Addendum No. 2
December 10, 2021

Project: Harrisburg High School - 9th Grade Academy
Sioux Falls, South Dakota
Architecture Incorporated Project #2904

Architect: Architecture Incorporated

N
SECOND FLOOR PLAN - AREA B - LIGHTING
SCALE 0 4 8 12 16

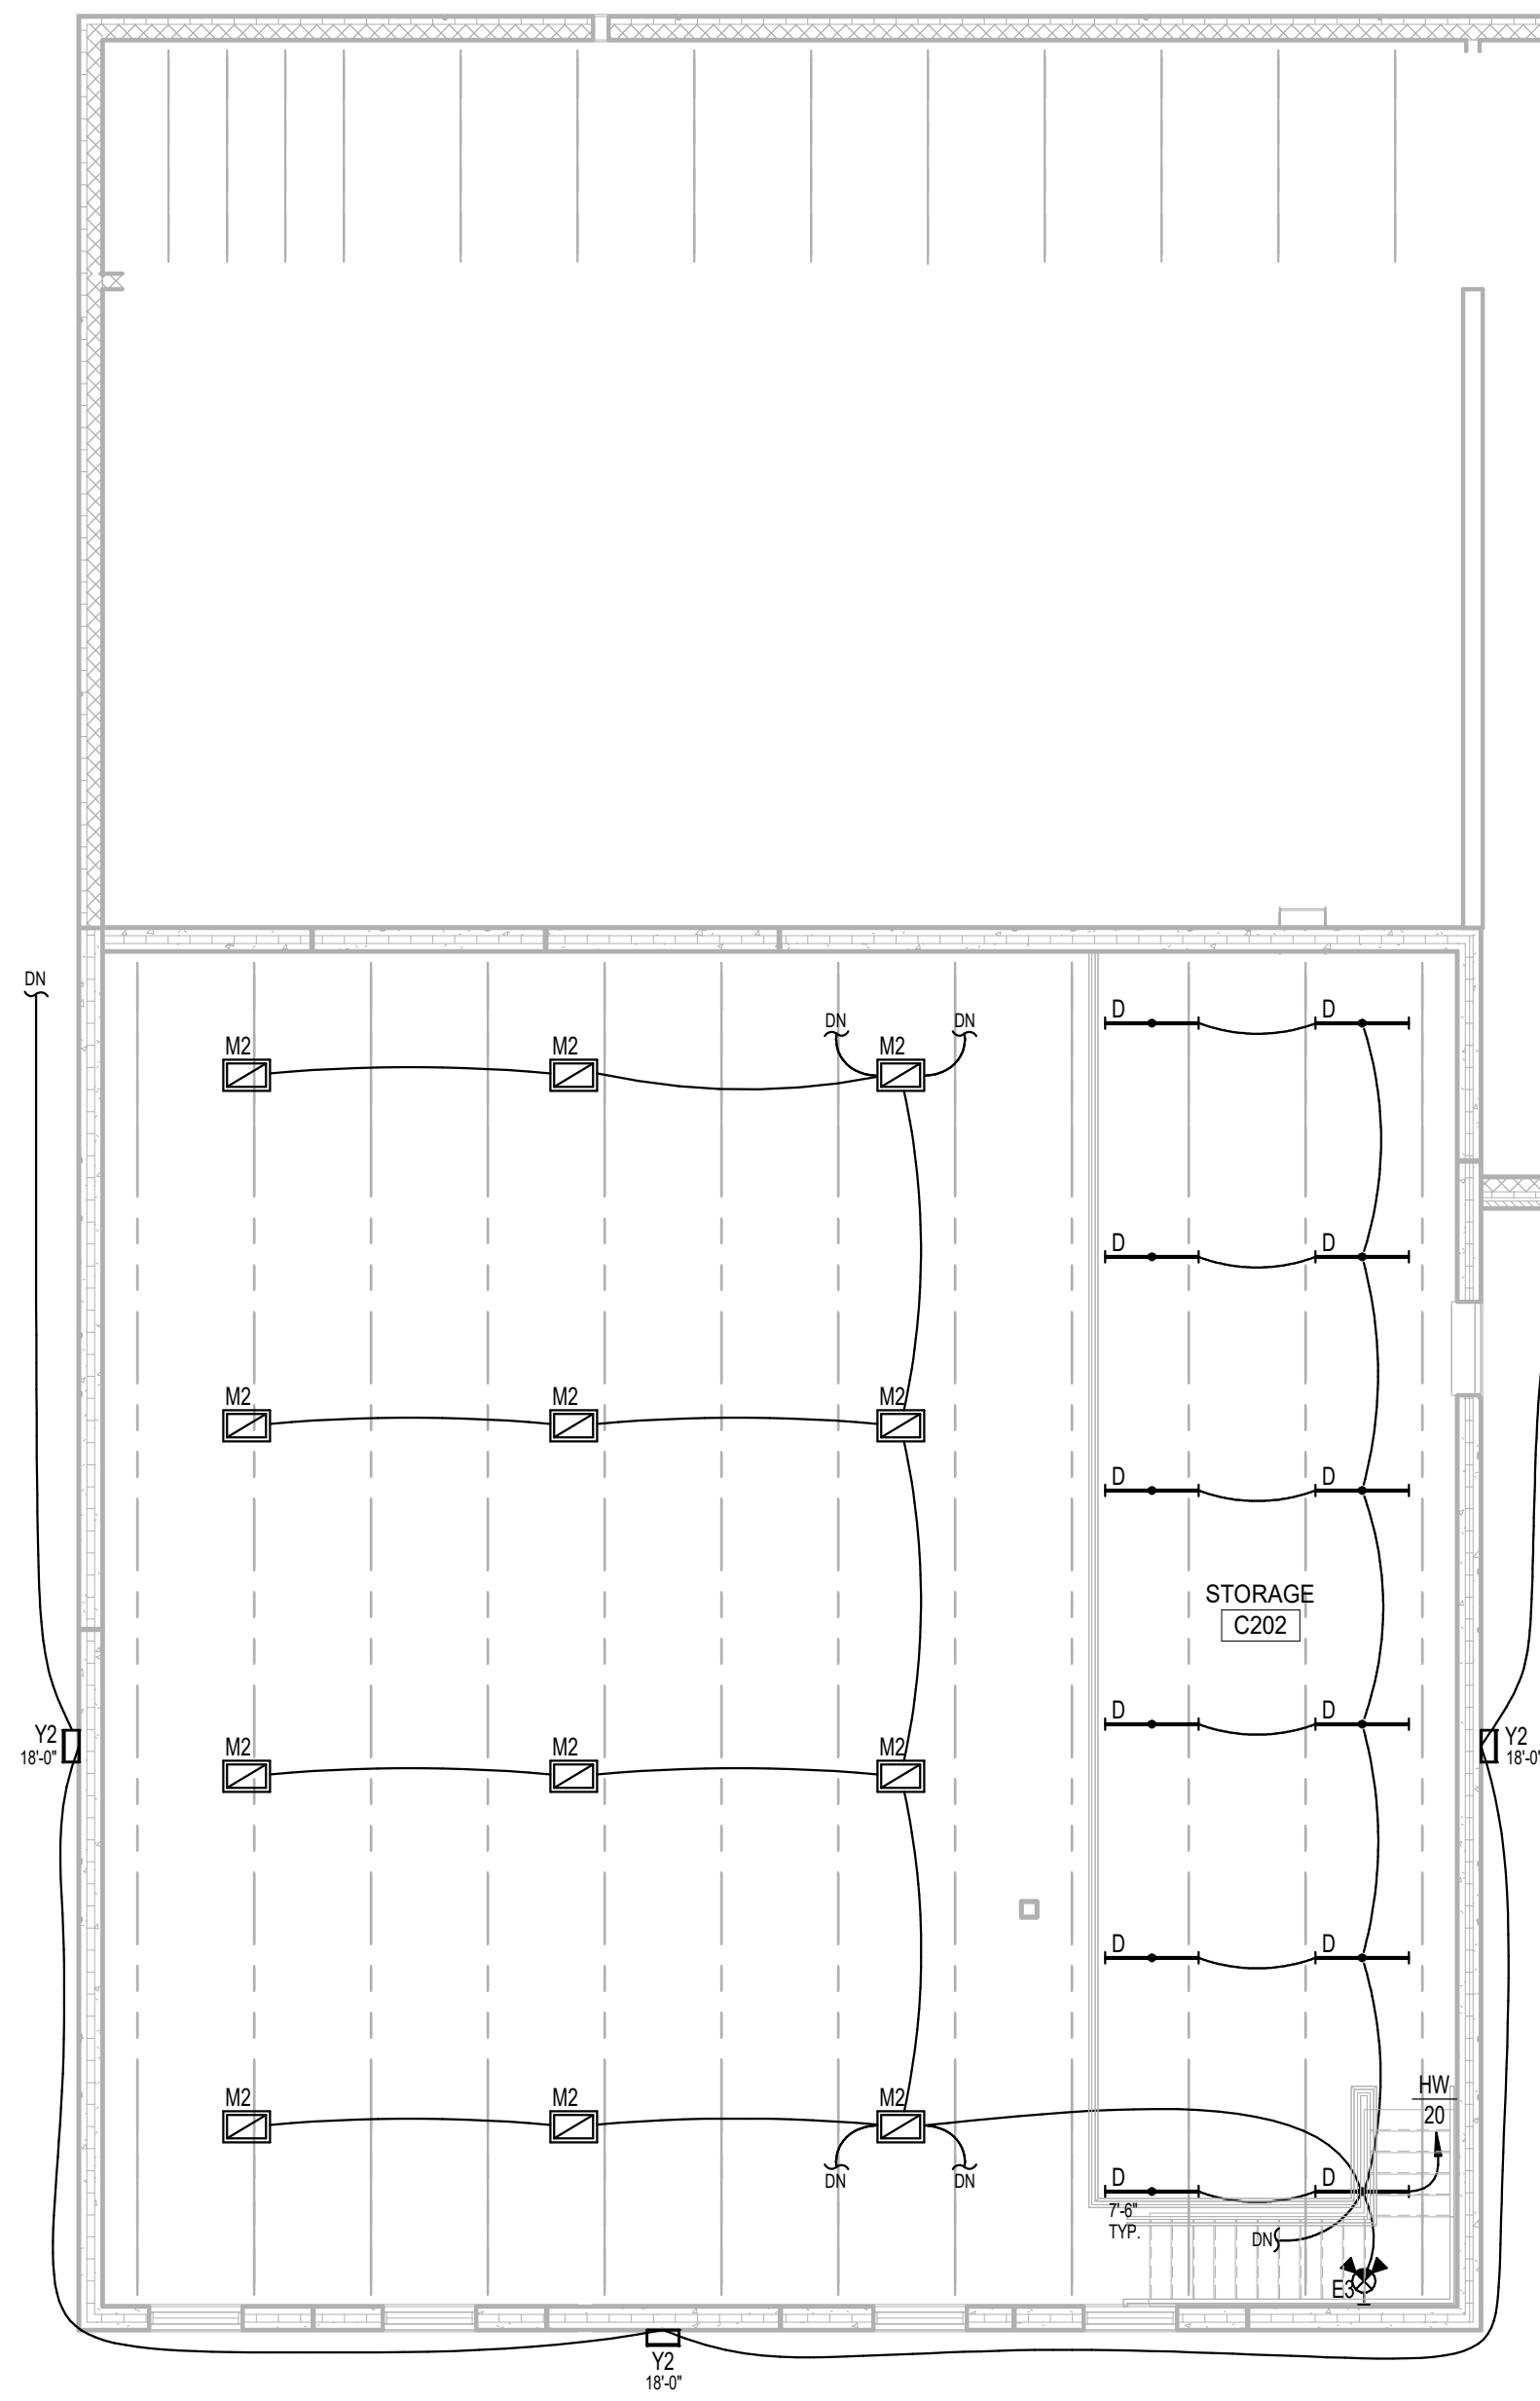
- a) Reference revised electrical drawing 9.34-2B, revision dated 12-10-21, attached to the end of this addendum for lighting modifications in Commons B200.

SECOND FLOOR PLAN - AREA C - LIGHTING

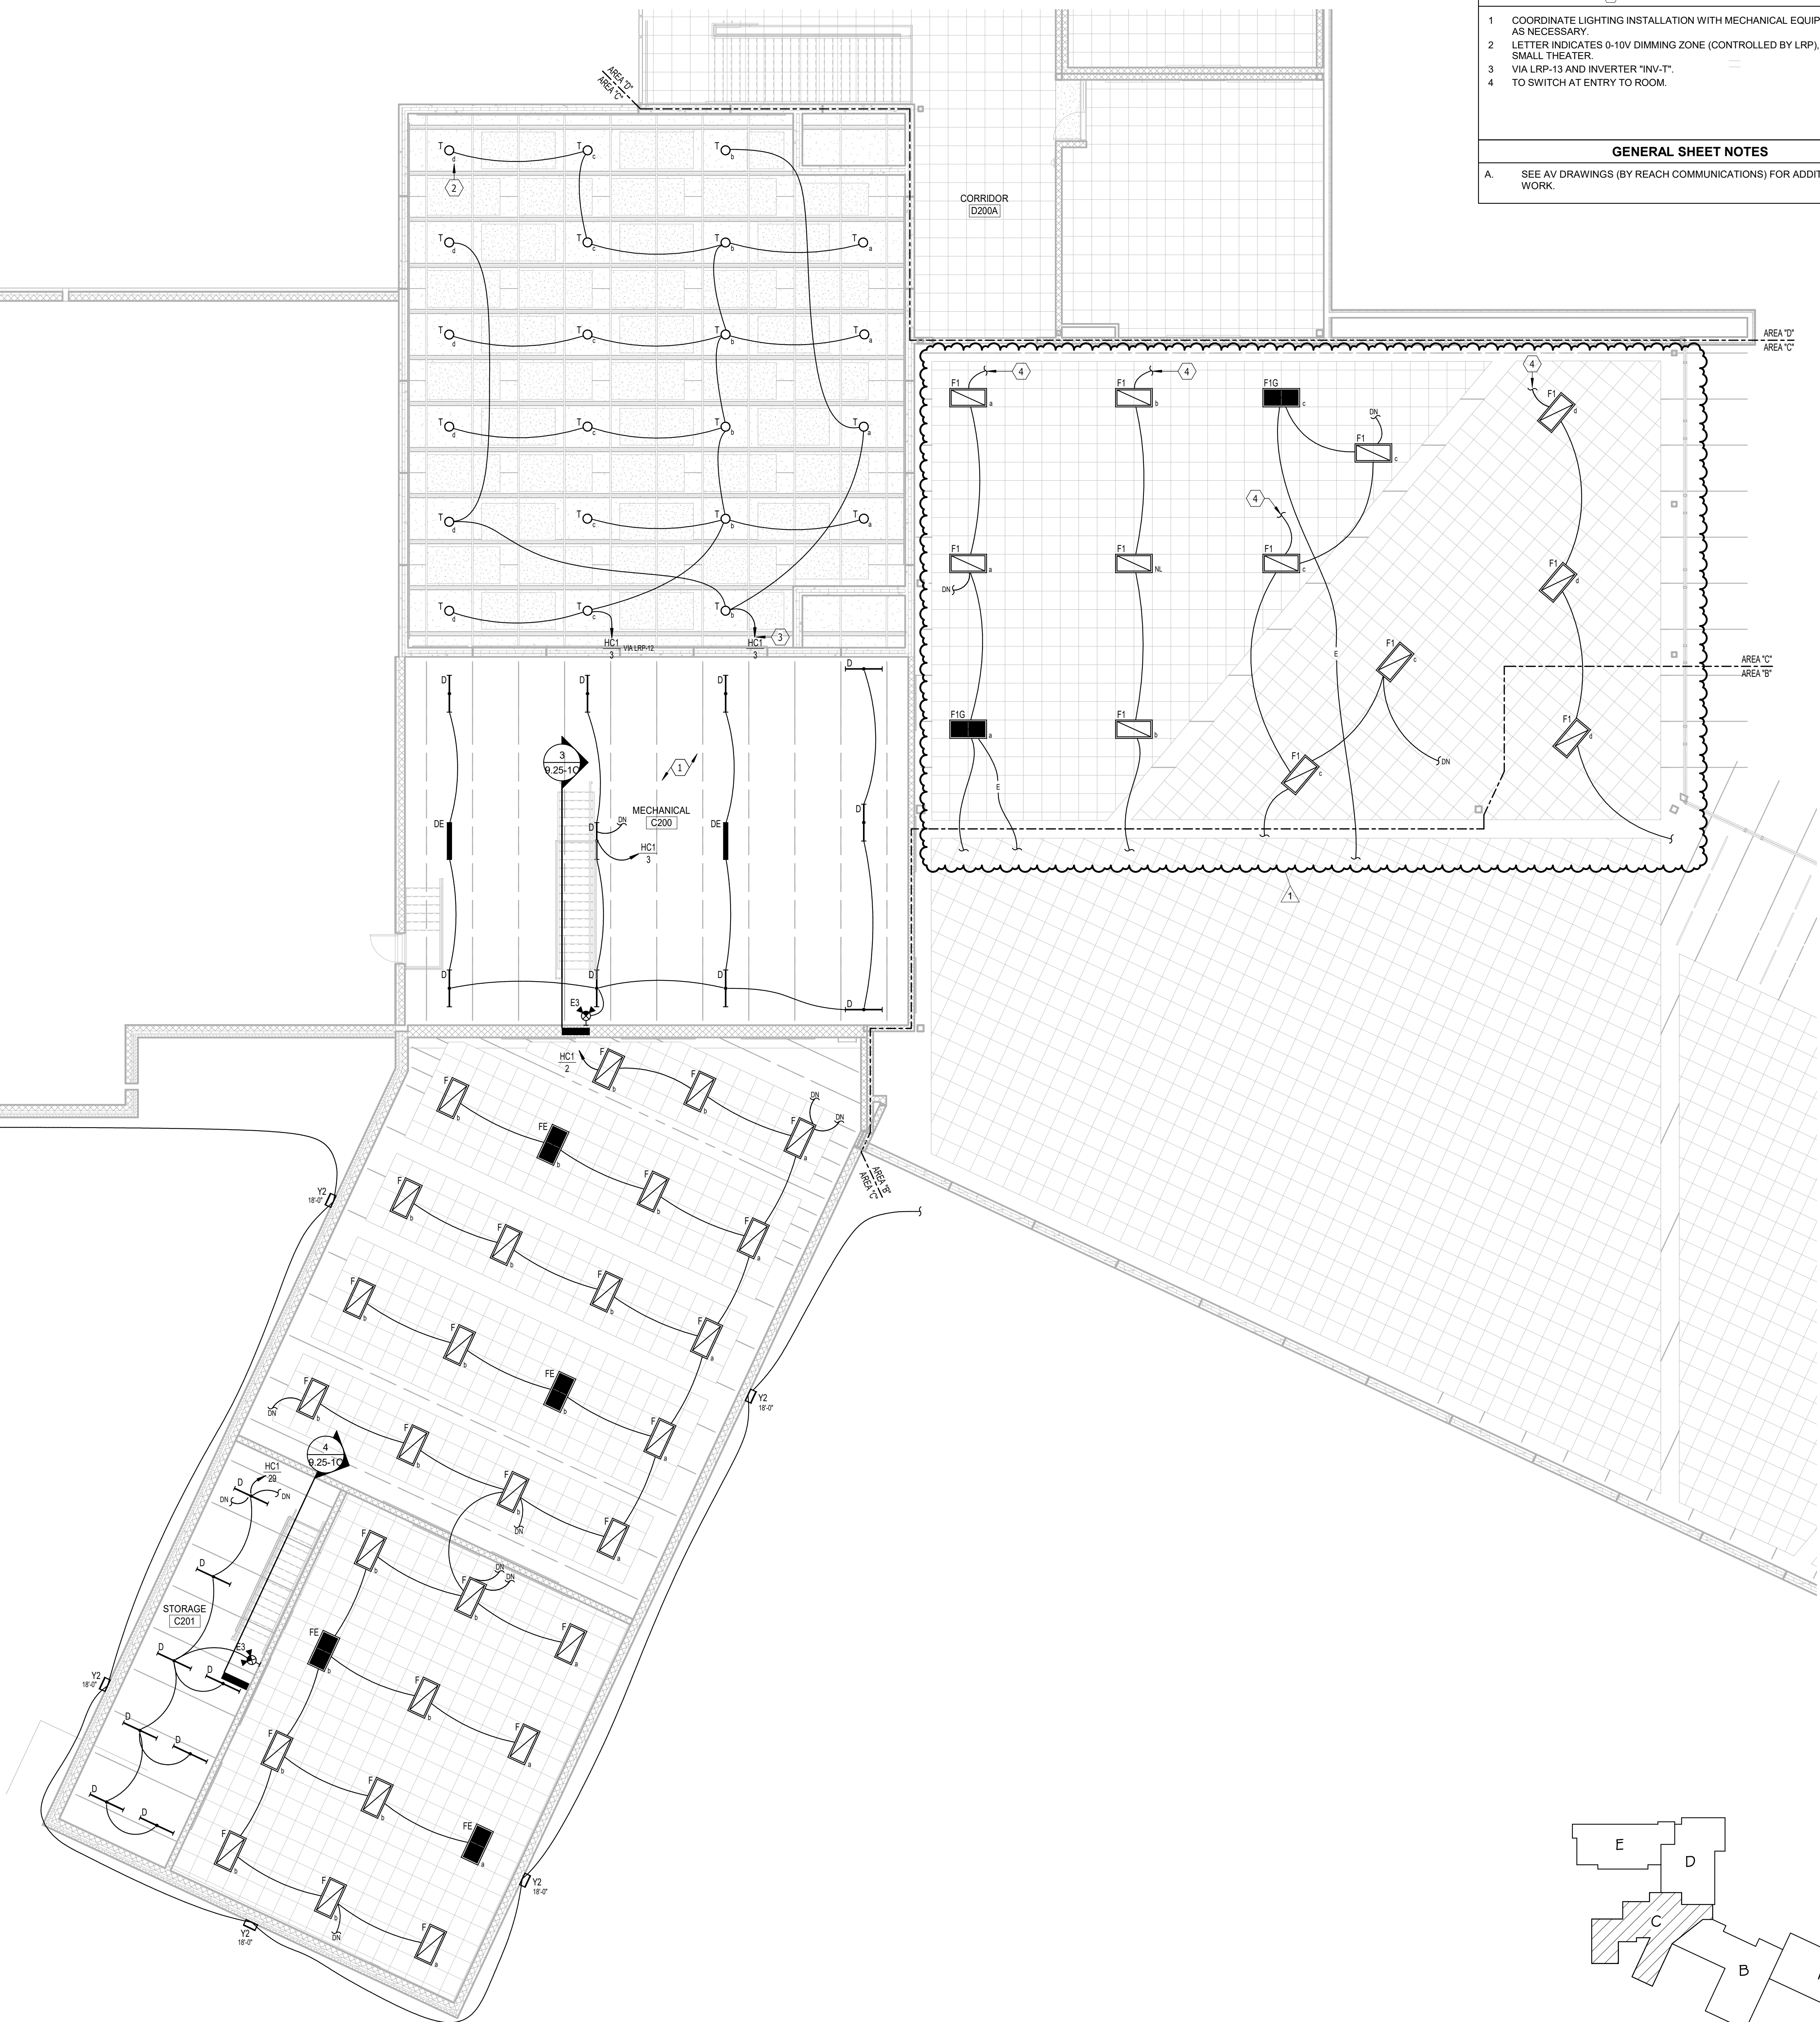
- a) Reference revised electrical drawing 9.36-2C, revision dated 12-10-21, attached to the end of this addendum for lighting modifications in Commons B200.
